Service Bulletin

S.B. No: 175

Title: INSPECTION OF CONTROL COLUMN HOUSING BRAZING

Applicability: T67A, T67B, T67C, T67M, T67M-MkII, T67M200, T67M260 and T67M260-T3A.

FIGURE 1

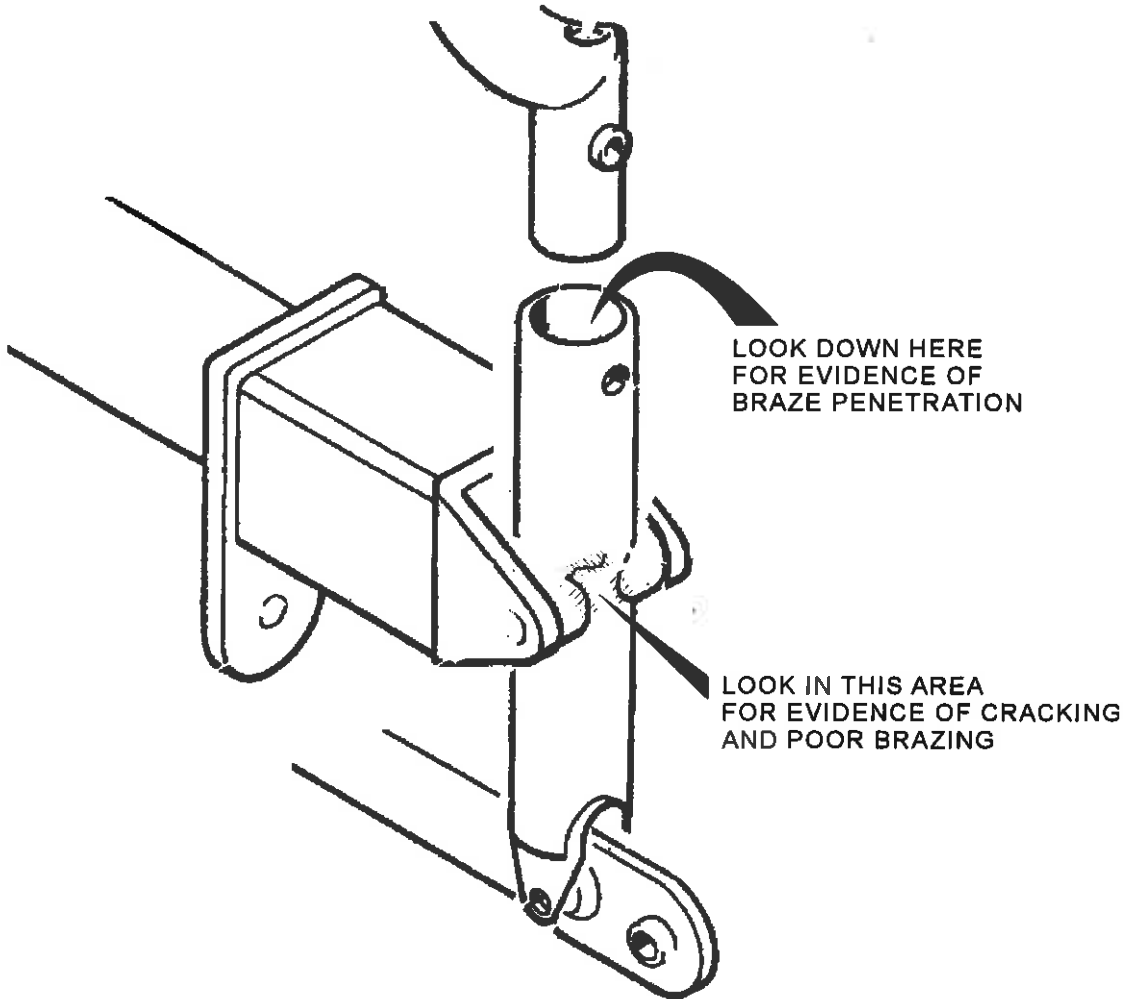
Cases have been reported of cracking in the area of the joint between the bearing housing and the vertical tube into which the control sits.

On inspecting the individual housings, one crack was found in the brazed joint and another crack was found in the vertical tube itself. The latter crack had occurred during sub-contractor manufacture and had been brazed over.

1. Check master switch, ignition switch and fuel are OFF. Disconnect external power and hangar aircraft if required.
2. Gain access either through gaiter or remove access panel.
3. Visually inspect for cracking as indicated by Figure 1 page 2.
4. If cracking found remove item and replace with new item T67B-45-217.
5. If no cracking present but if unsure, or poor brazing is suspected then:
 - a. Remove control column and visually check for braze penetration.
 - b. Remove paint locally and perform NDT (dye penetrant) crack test.
6. If either 5a. and/or b. are unsatisfactory, then replace with new T67B-45-217 item. If satisfied re-protect bare metal and re-assemble.
7. Annotate logbook "SB 175 complied with" and finally at fitting of new item "SB 175 complied with new item fitted."
